Applicant's Responses to Deadline 5 Submissions and Other Requests for Information

The West Midlands Rail Freight Interchange Order 201X

APPLICANT'S RESPONSES TO DEADLINE 5 SUBMISSIONS AND OTHER REQUESTS FOR INFORMATION - DOCUMENT 16.1

Figure 1: Macmillan Way - Cross Britain Way (source: the Long Distance Walkers Association)

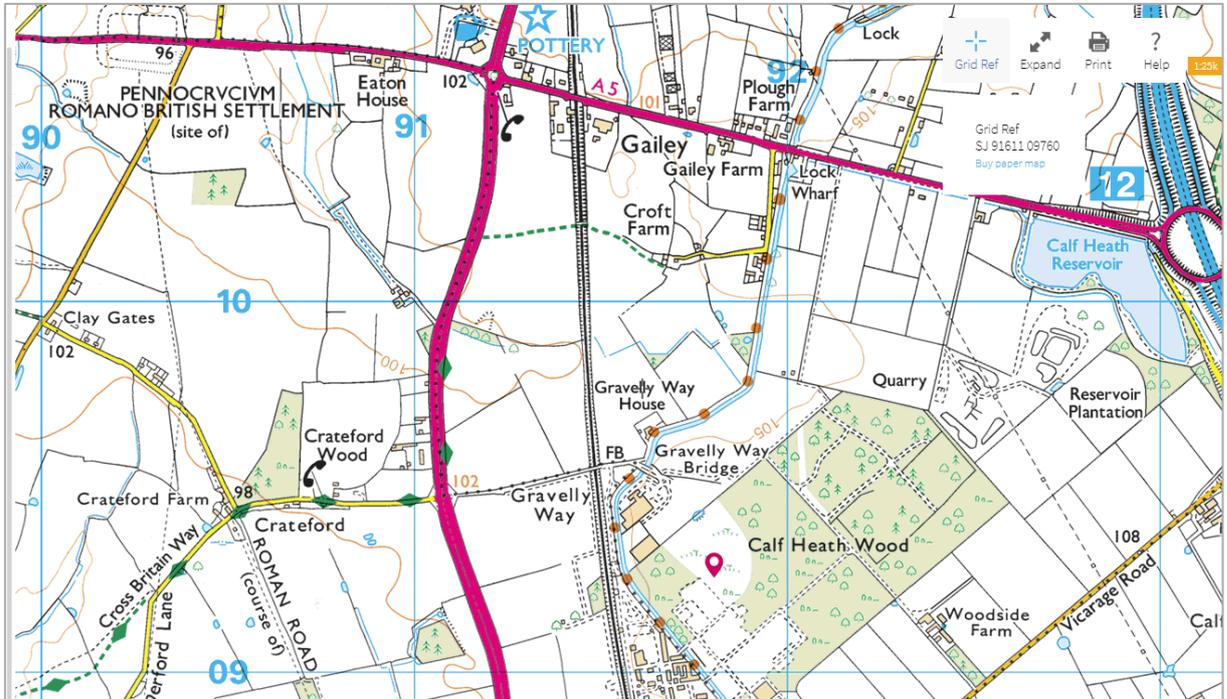
Tim Brunton 16.1.030	<p><u>Cross Britain Way</u></p> <p>I have only just found out about the proposed development in the last few days. I understand the developers only discovered the existence of Cross Britain Way in the last few weeks despite our waymarker stickers on Penk29. It has also been shown on OS online mapping since last year and sheet maps</p>	The Applicant has reviewed the latest OS online mapping information. This shows part of the Cross Britain Way (CBW) in close proximity to the Site, however, the section of the Cross Britain Way that runs through the Order Limits is not identified on the OS online mapping as being part of the CBW. See Appendix 3 .
